# SERVICE BULLETIN

Classification: EC14-005a	Reference: NTB14-103a	Date: February 10, 2015
------------------------------	--------------------------	----------------------------

## 2013-2015 FRONTIER; FUEL TANK HARD TO FILL

This bulletin has been amended to include 2015 Model Year. Please discard the previous version.

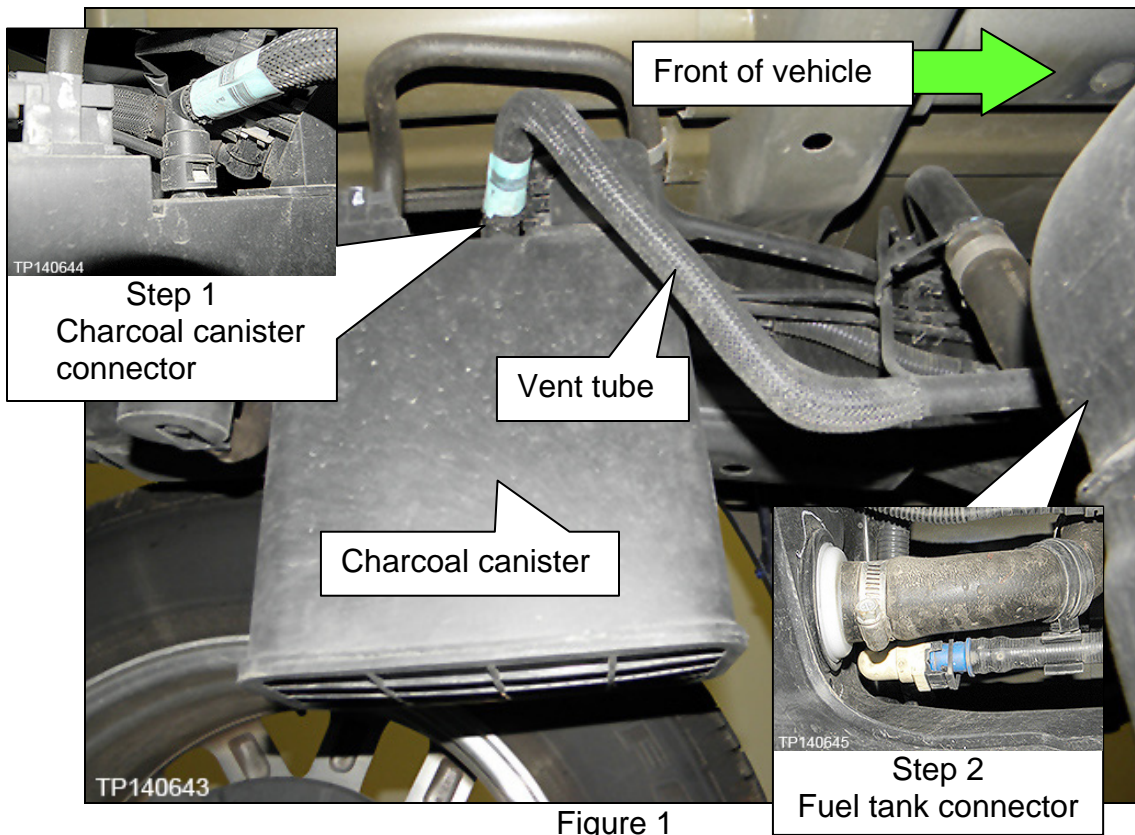
1. Disconnect vent hose at canister.

**NOTE:** See Figure A and Figure B for detail of "Quick connector" retainer release.

2. Disconnect vent hose from fuel tank.
3. Install new vent hose.
